UNITED STATES OF AMERICA
BEFORE THE
FEDERAL ENERGY REGULATORY COMMISSION

In the Matter of
Annova LNG Brownsville Project

CP16-480

COMMENTS ON THE DRAFT ENVIRONMENTAL IMPACT STATEMENT FOR THE
PROPOSED ANNOVA LNG BROWNSVILLE PROJECT

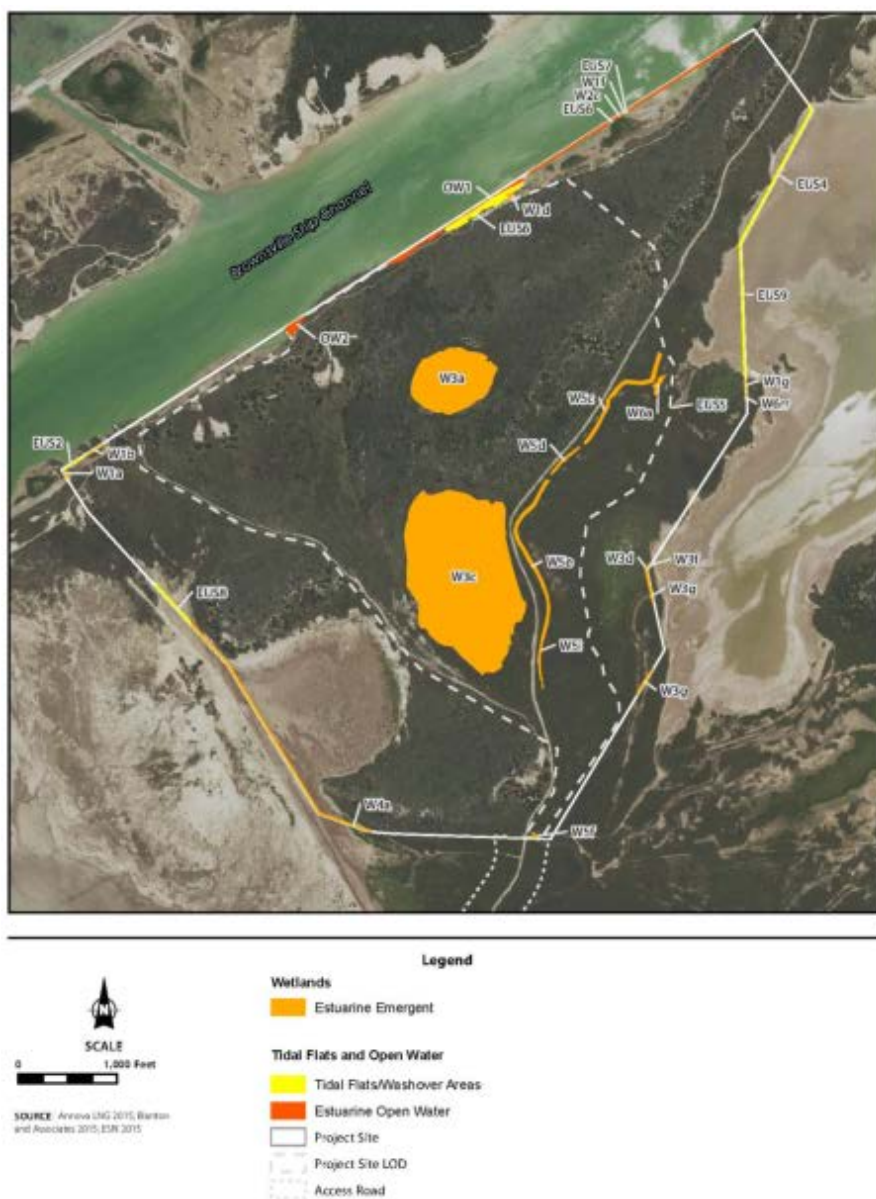
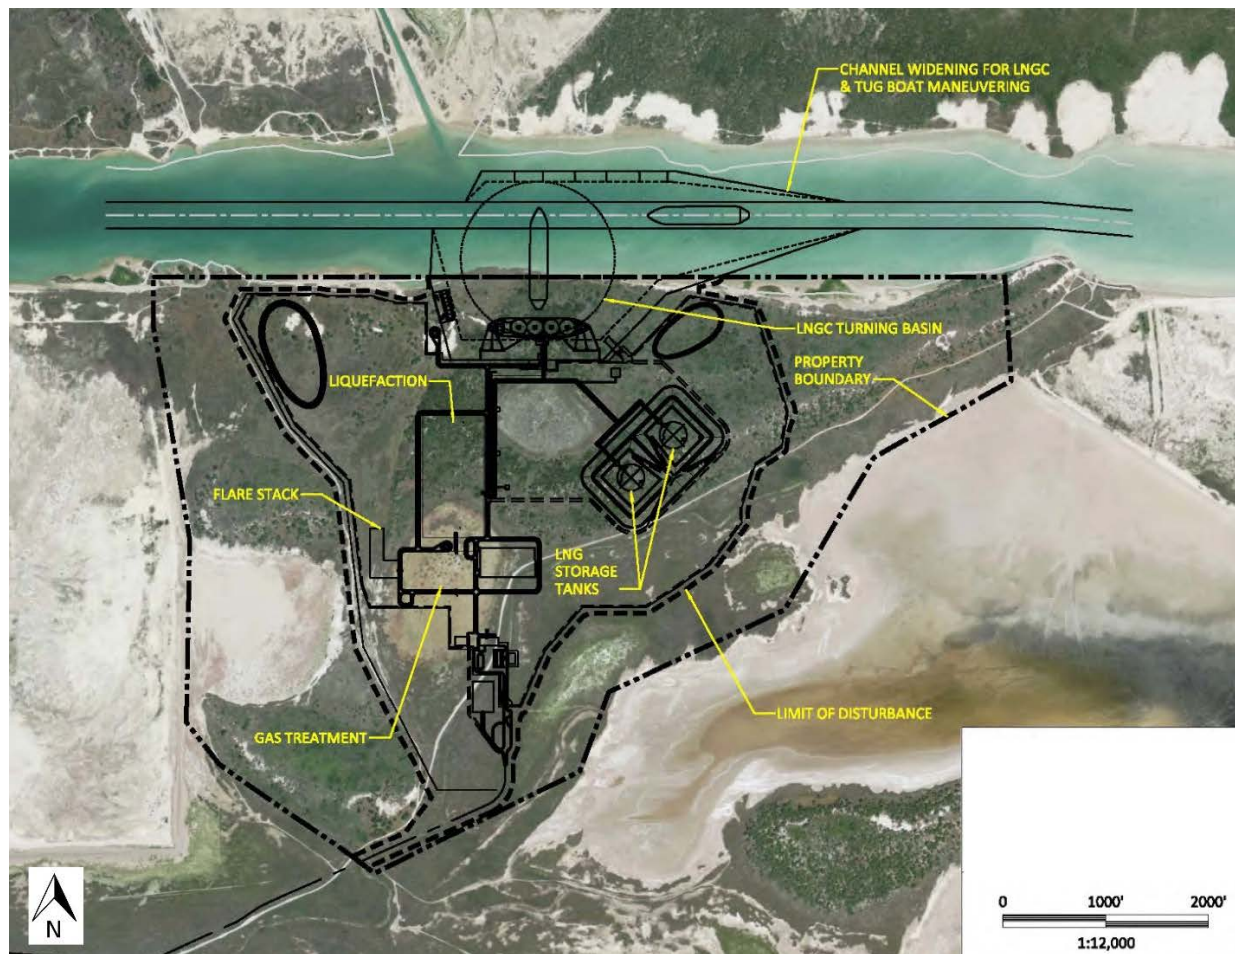
For example, much of Annova's wetland impacts will be caused by pretreatment and storage, rather than marine transfer, facilities. Annova predicts that the project will permanently disturb 40 acres of wetlands, primarily "estuarine emergent". DEIS 4-29 to 4-300. The majority of these wetlands are at the terminal site, as shown in DEIS figures 4.4.2-1 reproduced below.

The proposed Annova facility design would fill these wetlands, as illustrated by DEIS figure 1-2, reproduced below (note the change in orientation):

In the proposed design, wetlands will be impacted by gas pretreatment facilities (which the Freeport project demonstrates can be located at a site miles away) and by liquefaction equipment (which Cove Point demonstrates can be a mile from marine loading facilities). NEPA requires that FERC take a hard look at alternatives that would follow the approaches used at Freeport or Cove Point to relocate these facilities and thereby reduce wetland impacts. Similarly, NEPA further requires a hard look at the extent to which a smaller facility, with fewer liquefaction trains, could reduce these impacts.

DEIS, Figure 4.9.3-1.

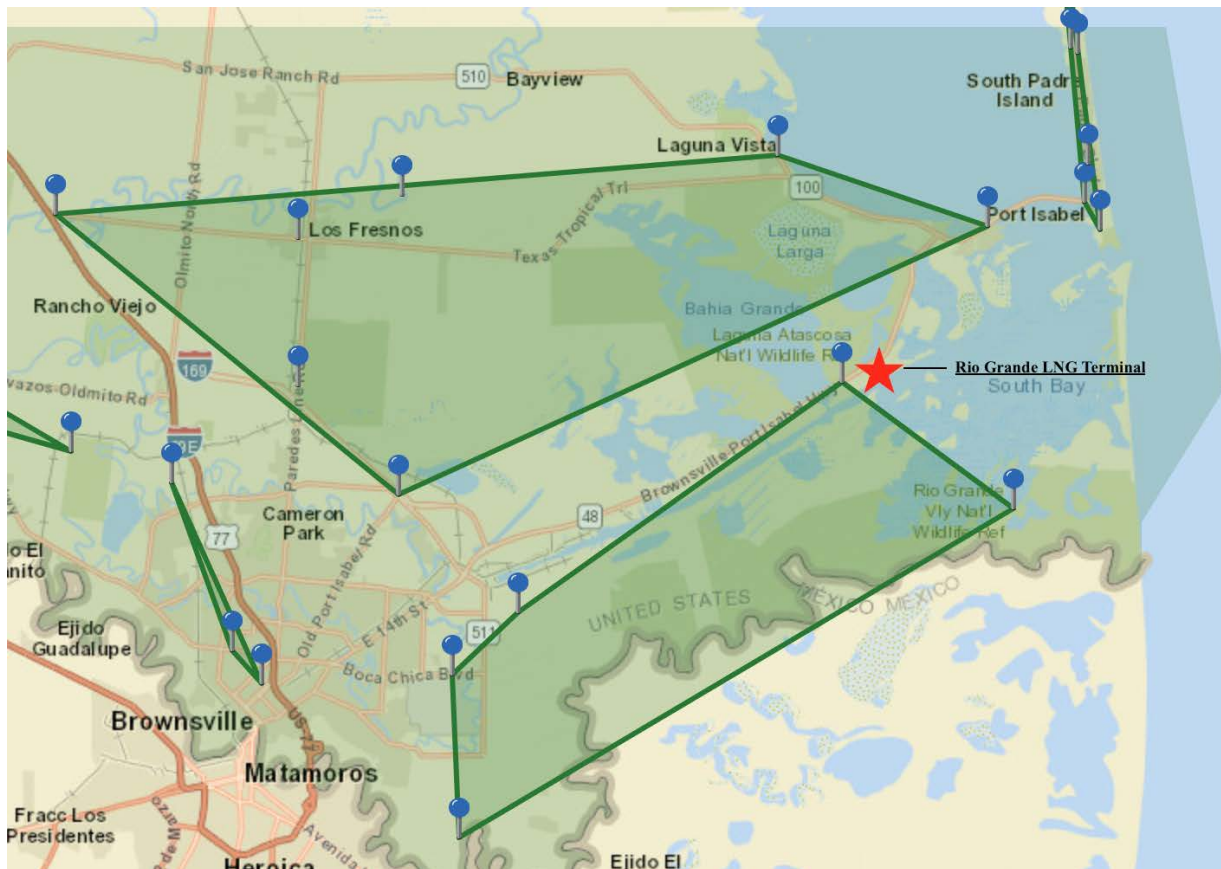
The Rio Grande Valley is one of the top bird watching destinations in the country.⁶³

⁶³ See DEIS, Figure 4.9.3-1 reproduced above.

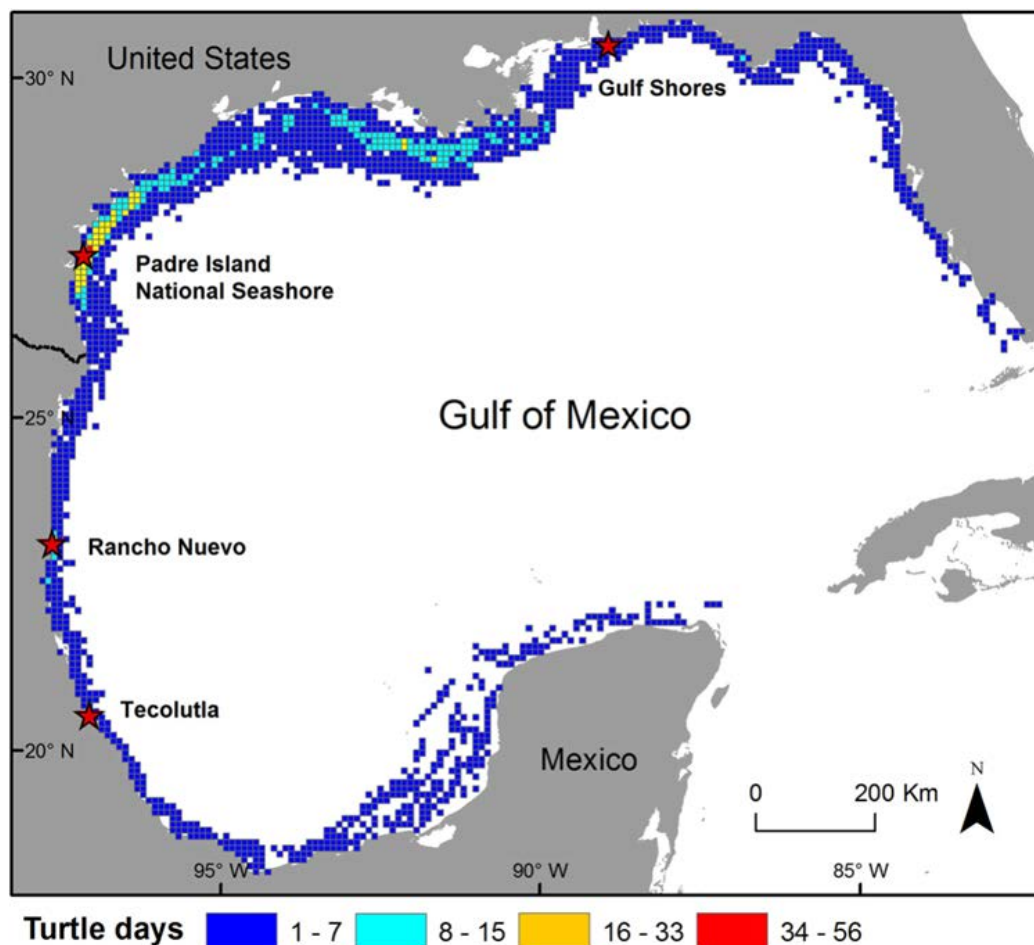
Annova LNG does not adequately evaluate the potential for collision with ships as a significant risk to sea turtles associated with the project, both directly and in conjunction with the increased traffic resulting from the two other terminal projects.²²⁹ Turtles are vulnerable because they surface to breathe; often bask, feed, and mate near the surface where they are struck; and are more vulnerable during cold spells when they are unable to move as effectively. They are also more vulnerable when ships travel at high speed because the turtles cannot take effective evasive action.²³⁰ The bodies of most struck turtles are not recovered, but dead and injured turtles that wash up on shore include turtles clearly struck by ships. NOAA collects statistics on turtle strandings off the Texas coast, although these statistics are not broken down by cause of death. In Zone 21 of NOAA's Gulf of Mexico sea turtle coastal habitat zoning, the number of strandings of all threatened or endangered species of sea turtles from 2010 to 2018 was 3,390. This includes the area of Padre Island and South Padre Island (offshore and in-shore strandings).²³¹ Some proportion are likely due to collision and could increase as a greater number of ships enter the Brownsville ship channel arriving at the three new LNG terminals. To comply with NEPA, the Annova LNG EIS must analyze this issue.

Turtles are known to be present in high density in this area, as shown in the map below, so

many ship-turtle collisions are likely.²³² The Annova LNG project and other LNG projects planned along the shipping channel will significantly increase the amount of ship traffic in the area, thereby increasing the probability of collision and turtle death. This may especially negatively impact nesting beaches for the Kemp's ridley, which nest along Boca Chica beaches in South Padre island at the entrance to the ship channel. The project documentation fails to quantify the increased vulnerability to vessel strikes, and therefore—contrary to NEPA's requirements—it is impossible to determine whether vessel strikes associated with the project are causing significant adverse effects on any of the listed sea turtle species.²³³
